Concept 1 YF-52 "Coyote", S = 375 sqft

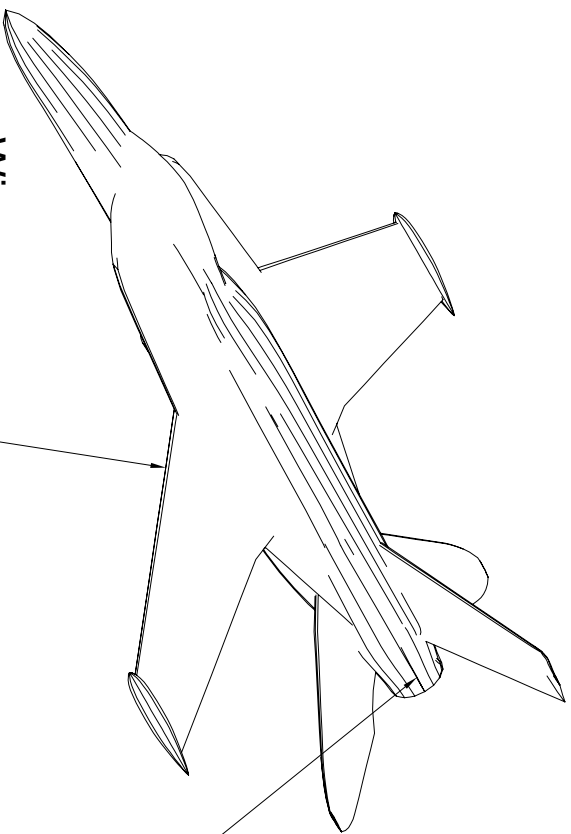
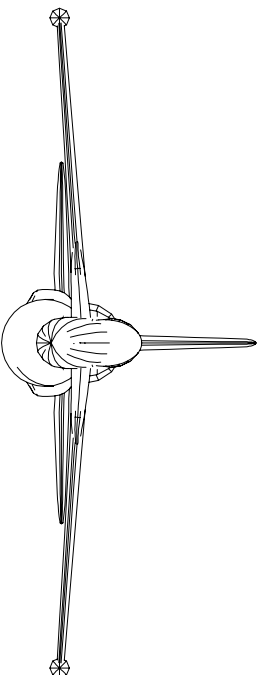
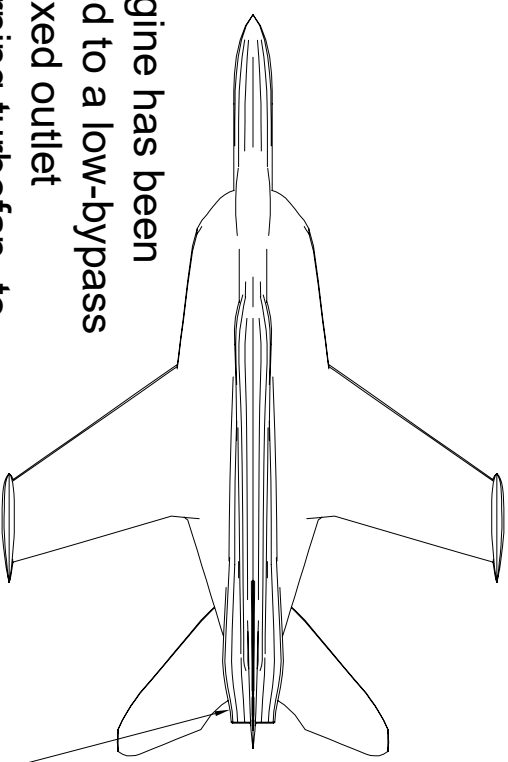
Wing area was also updated to be consistent with the sized value.

The engine has been changed to a low-bypass ratio mixed outlet afterburning turbofan, to best achieve the mission parameters.

Note change of nozzle shape and size
